**ITEM 6. DEVELOPMENT APPLICATION: 19 CARILLON AVENUE  
CAMPERDOWN****FILE NO: D/2013/1973****DEVELOPMENT APPLICATION NO: D/2013/1973****SUMMARY****Date of Submission:** 18 December 2013. Amended plans received on 17 September 2014.**Applicant:** St Andrew's College**Architect:** TKD Architects**Developer:** St Andrew's College**Owner:** The Council of St Andrew's College**Cost of Works:** \$97,845,000**Proposal Summary:** Consent is sought for a Stage 1 campus masterplan proposal, including site layout and building envelopes for new and existing buildings, to create up to 600 student and resident fellow rooms, a total of 159 car parking spaces, demolition, tree removal, landscaping and other site works. Works are proposed to be completed in stages over a period of 5 to 10 years. Stage 2 development applications will be submitted for the detailed design of the buildings.

**SCHEDULE 1A****Approved Development/Design Modifications/Covenants and Contributions/Use and Operation**

**Figure 26:** Amended Health Service Facility viewed from Missenden Road

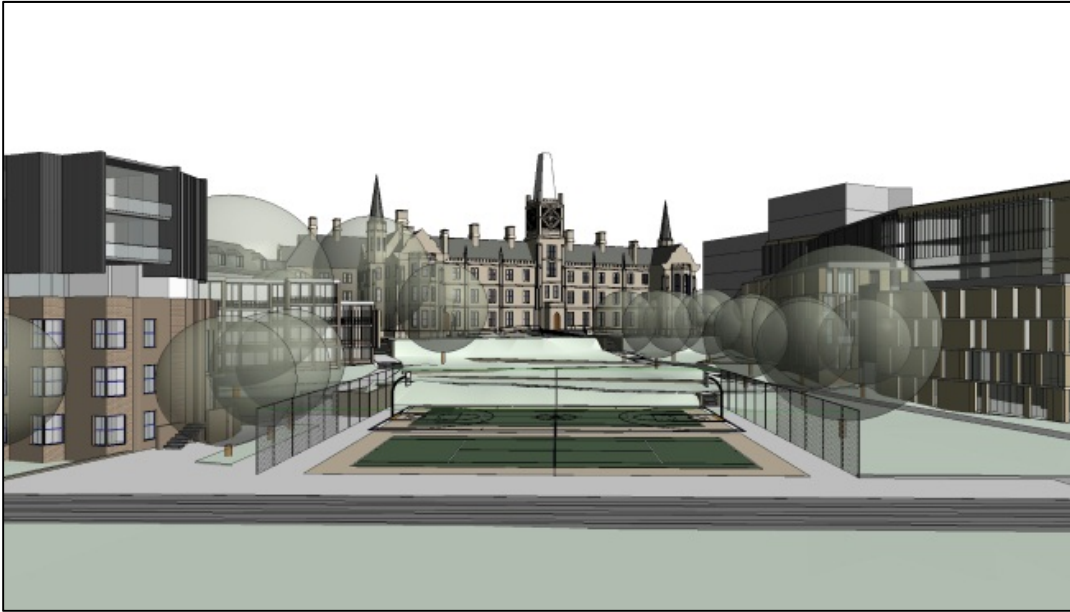
59. However concerns still remain regarding increasing the height of envelope to accommodate the plant level will increase the visual impact on this significant building. Council's Heritage Specialist and Urban Designer recommended that the top most level and any plant on it be shifted further east to the section that is marked as being RL 50.90, which will lessen the visual impact on both the Main building and the grounds of the College.

60. The figures below show that the plant level is not visible from Missenden Road, and when viewed from the College ground looking north and west, the plant level will be viewed against the backdrop of existing taller buildings within the RPAH campus and the Chris O'Brien Lifehouse building.

61. The bulk and scale of the amended proposal is considered to be generally acceptable in the context of the streetscape and adjoining heritage buildings, and is supported, subject to appropriate conditions. In this regard, a condition has been recommended requiring buildings the subject of Stage 2 Development Applications shall be wholly contained within the approved building envelopes. Further, the Stage 2 Development Application for the North building will be subject to a competitive design process, pursuant to Clause 6.21(5) as the proposed building envelope exceeds 25m in height.
